**LOCAL HISTORIC DISTRICT:** Dilworth

**PROPERTY ADDRESS:** 1919 Springdale Avenue

**SUMMARY OF REQUEST:** Rear addition

*Charlotte Historic District Commission Case 2017-328*  
**HISTORIC DISTRICT: DILWORTH**  
**ADDITION**

**A-11**

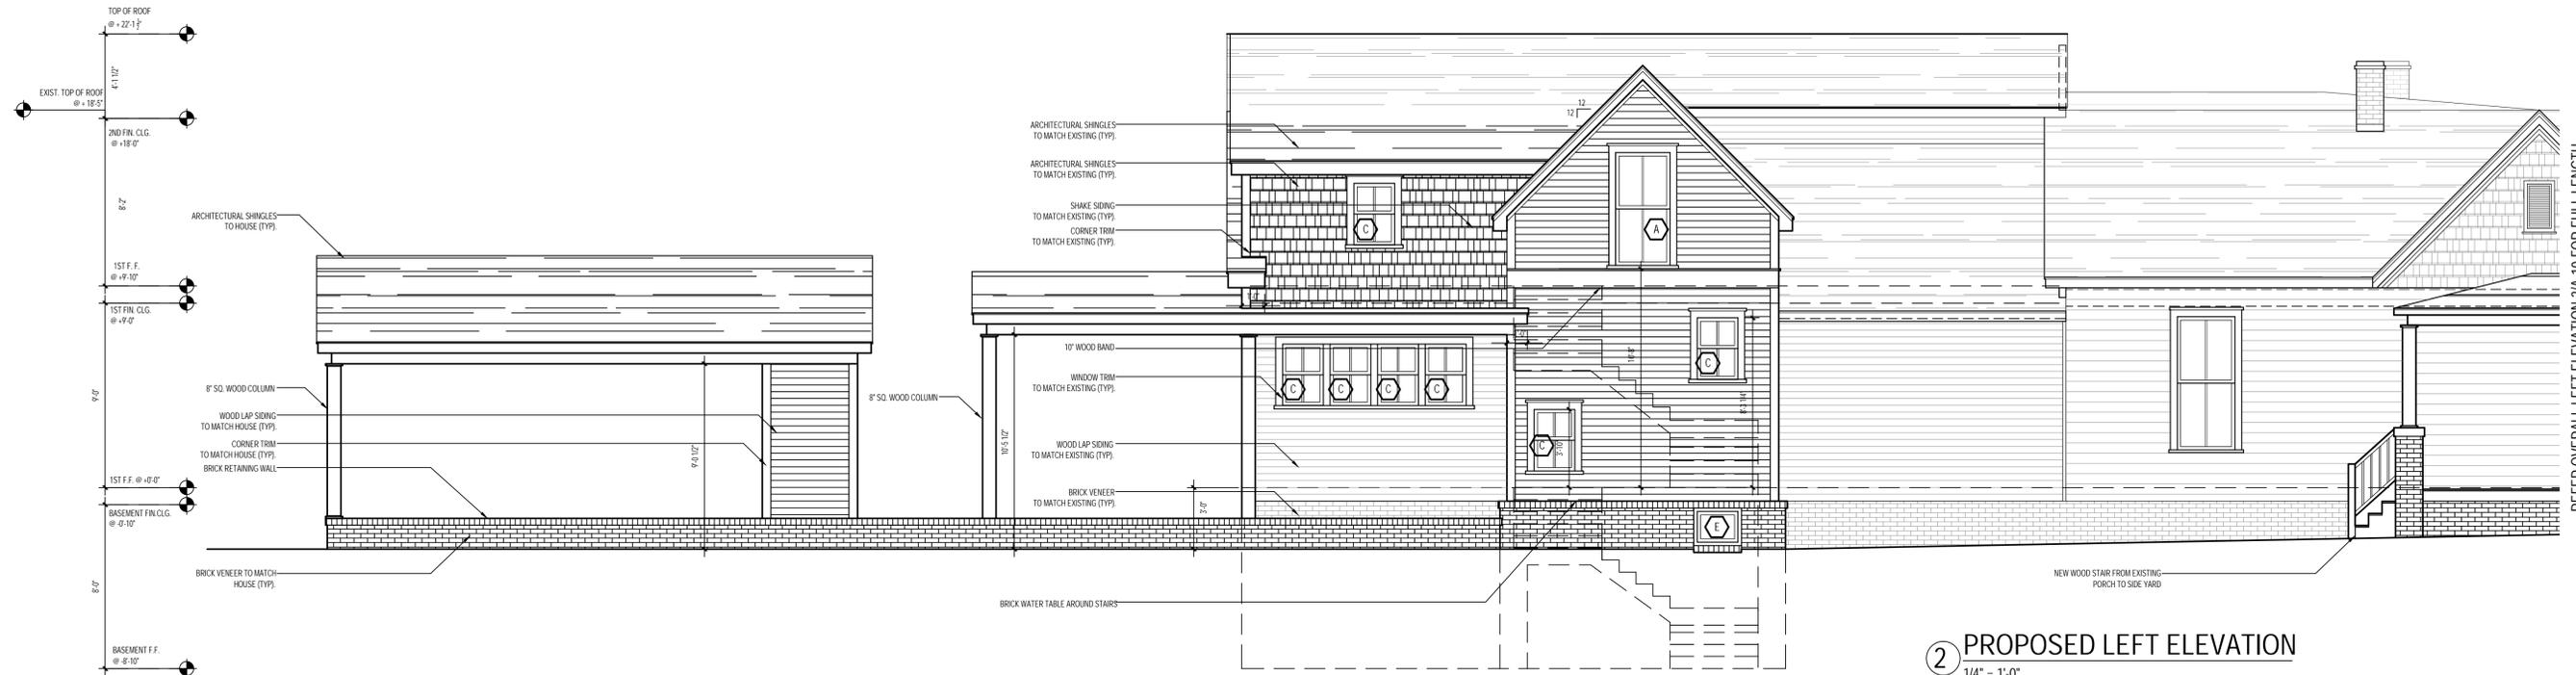
- 1. Massing of the roof to be more consistent and complimentary with the existing Victorian Style**
- 2. Windows to be proportioned closer to those on the existing structure**
- 3. Provide a revised landscape plan**

**1 PROPOSED ROOF PLAN**  
1/4" = 1'-0"

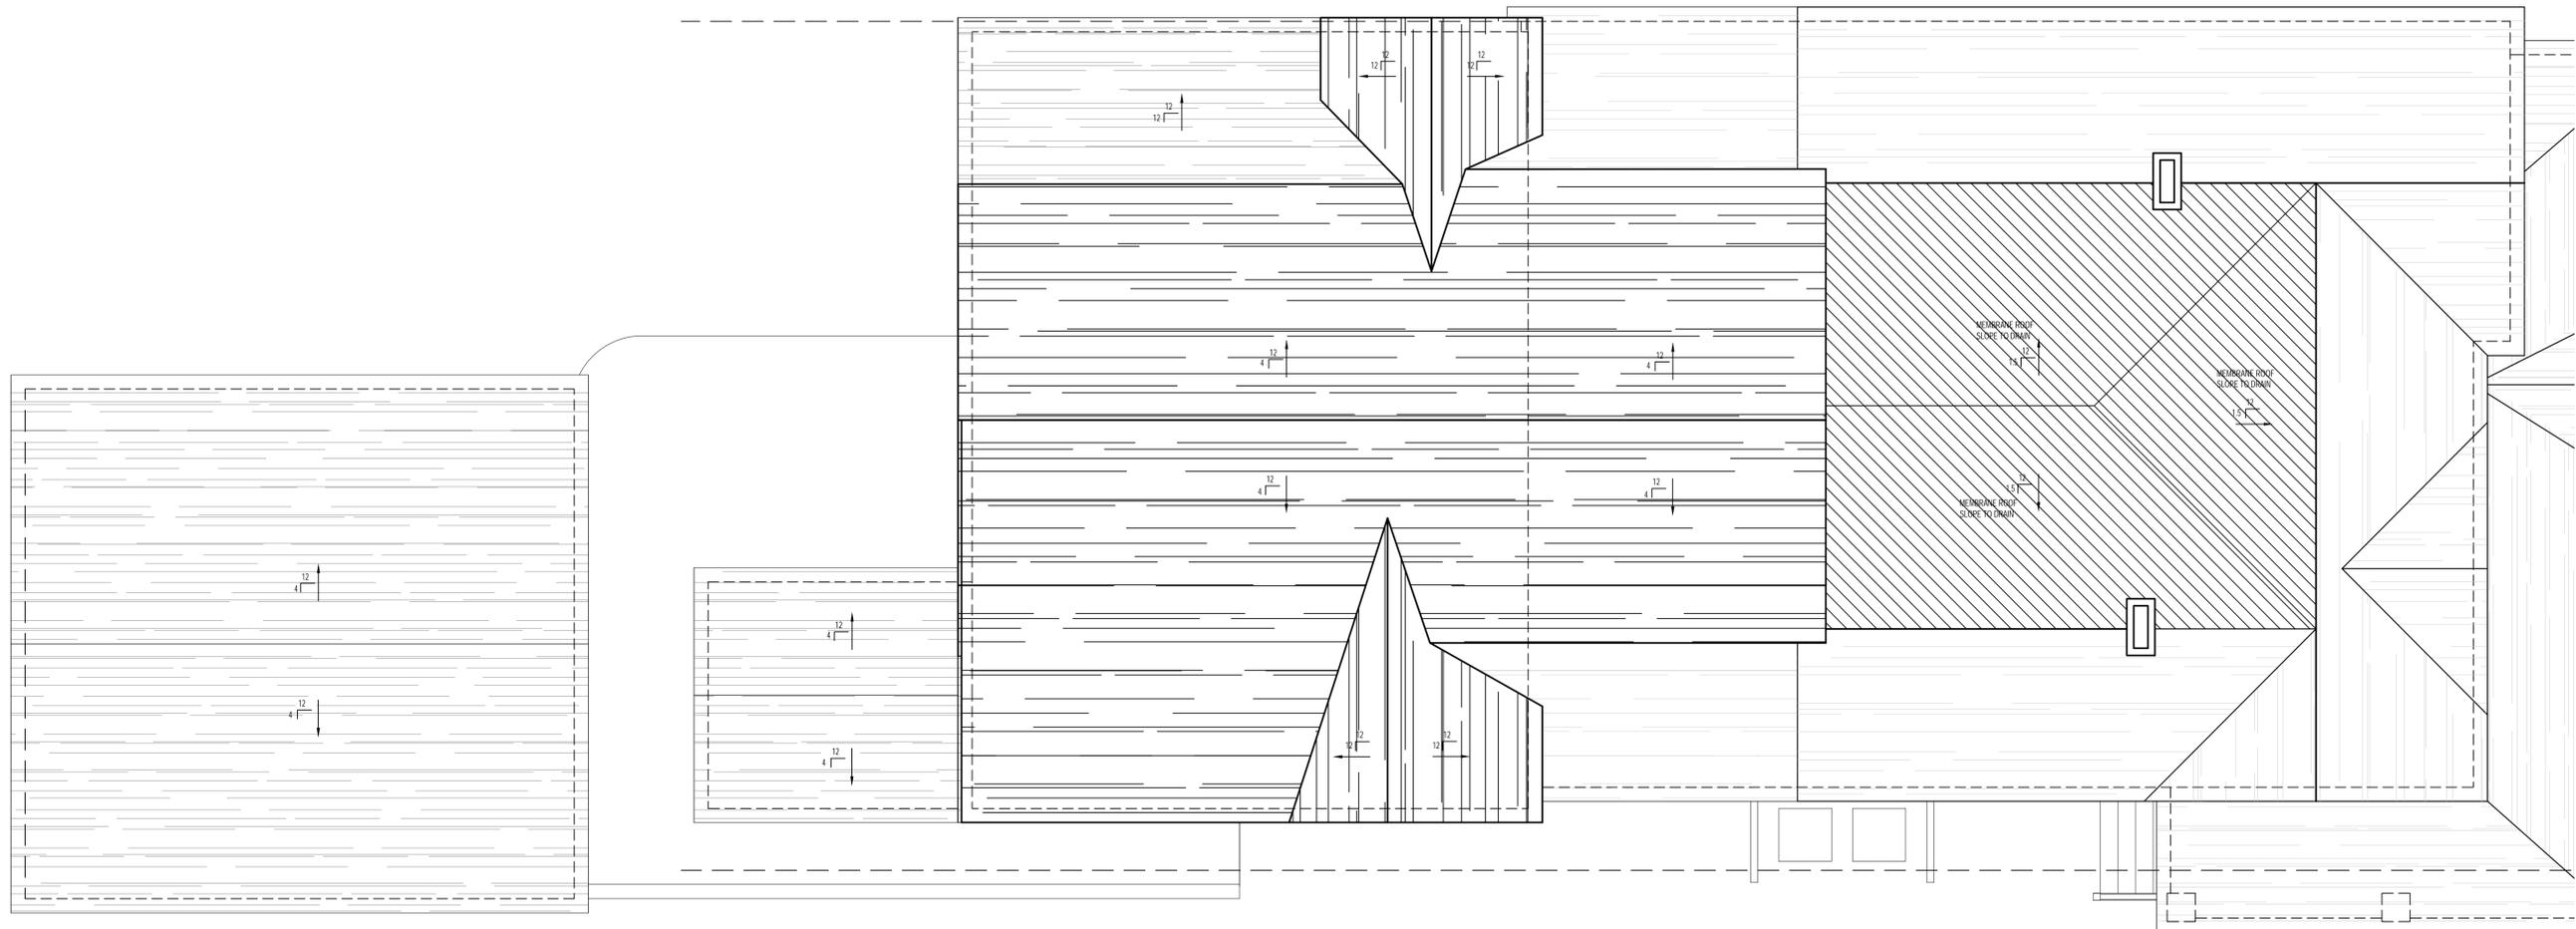
The application was continued from June for the following, 1) Massing of the roof to be more consistent and complimentary with the existing Victorian style, 2) New windows should be proportioned closer to existing, 3) Revised landscape/site plan with driveway proposed design. The applicant has included an administrative approval for a similar addition that also received approval for tax credits through SHPO.
